Engineer: P McGill		
Title: Coastal Profiling Float Motherboard: Power Supplies		
Size C	Document Number 11021161	Rev 1.4.0
Date: Thursday, March 31, 2016	Sheet 2 of 3

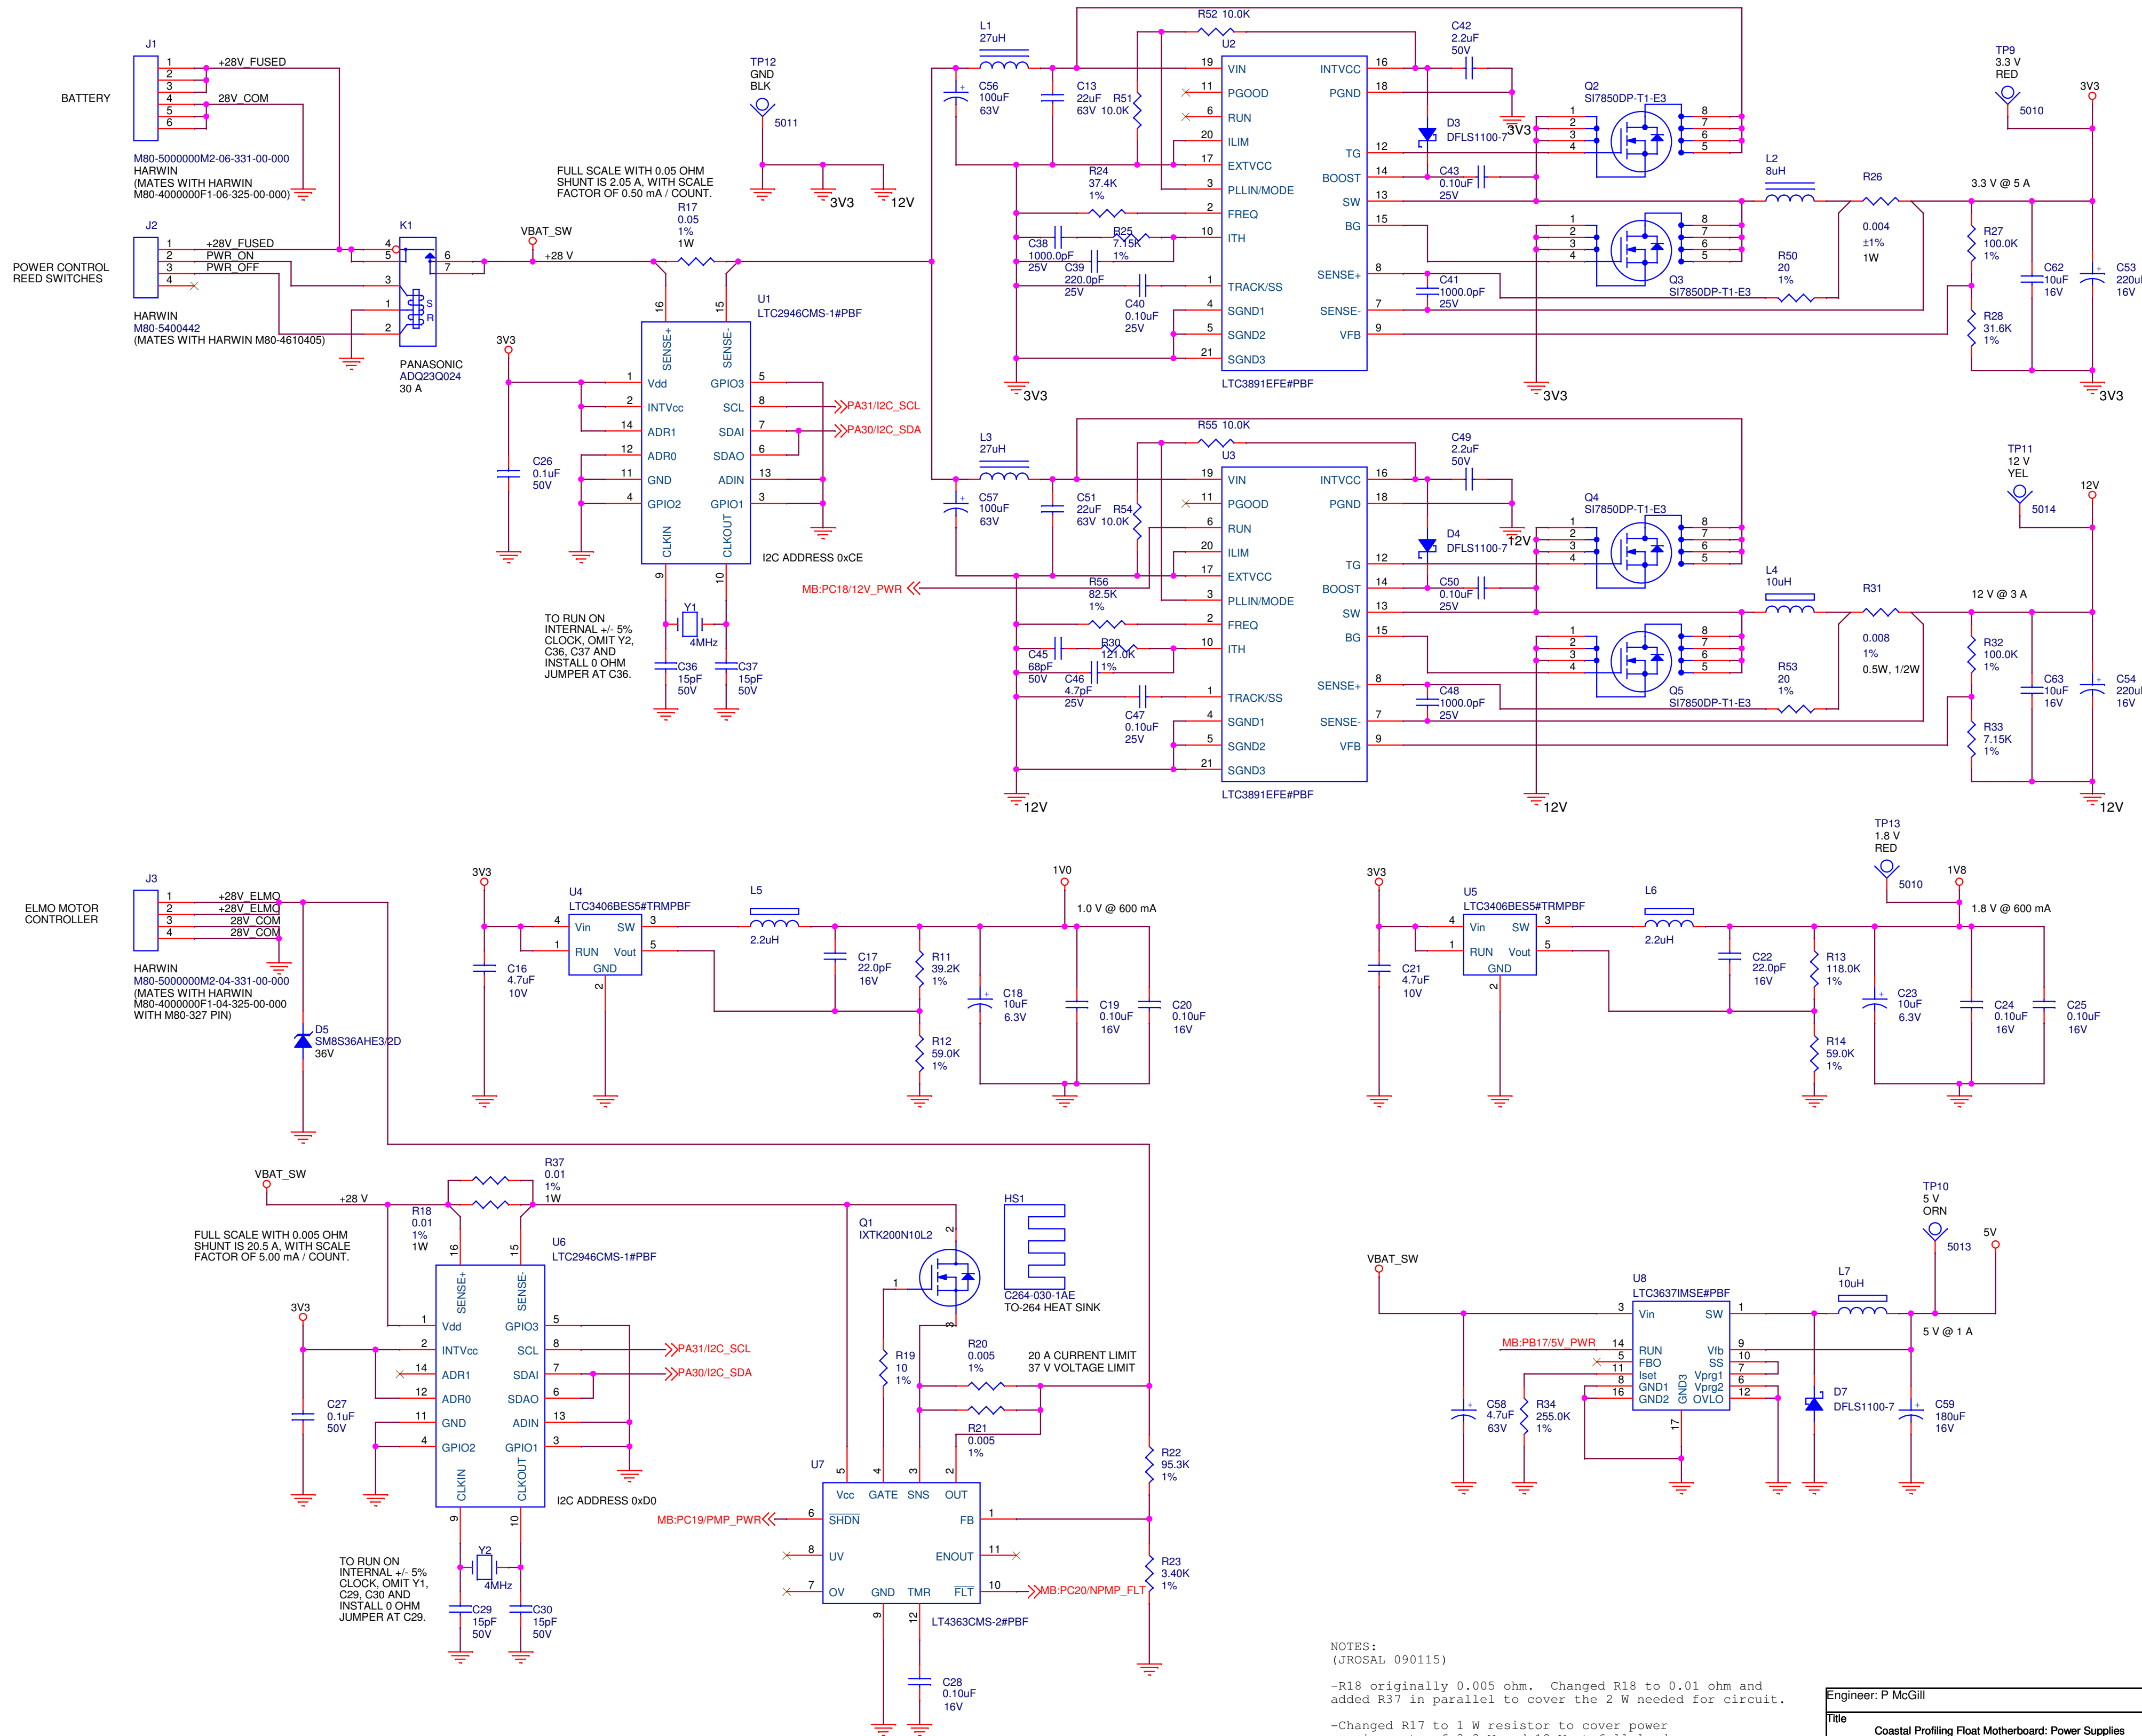
-R18 originally 0.005 ohm. Changed R18 to 0.01 ohm and added R37 in parallel to cover the 2 W needed for circuit.

-Changed R17 to 1 W resistor to cover power requirements of 3.3 V and 12 V at full load.
